# PlanGrid Task Report - Mar 11, 2025

L05290\_Maumee FSU (OH)

603 Pointe Blvd., Maumee, OH

# #128 [HOOD 508] [NEW] Sidejet arm angle bracket.

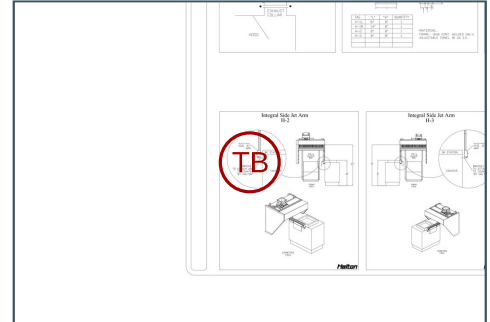
The Halton supplied angle bracket that connects the integral sidejet arm to the counter is missing or not installed correctly. Secure bracket to arm and bracket to counter underneath removeable fry dump via stainless steel rivets.

The bracket can not be riveted. if it is not removable the fryer will not be able to be pulled out. Also, this would void warranty.

Re-opened for lack of documentation. See plans, bracket connects sidearm capture jet to counter, not to fryer.

Brackets have been installed correctly. Ready for inspection.

# #123 [DUCT 501] [NEW] Insulation stick pins.

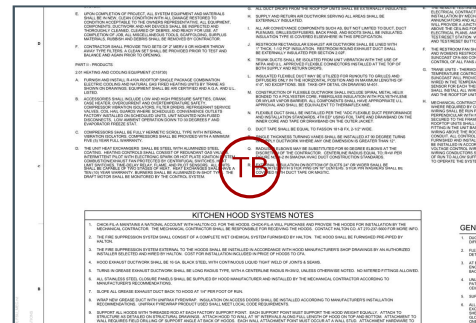
External insulation on bottom of ducts 24" or wider is to be supported by stick pins 18" on center. Cut pins and apply tape or mastic over stick pin washers.

Per direction by national tab missing mastic over pins

Re-opened for insufficient documentation. Cannot clearly see stick pins installed, insulation is bunched and sagging.
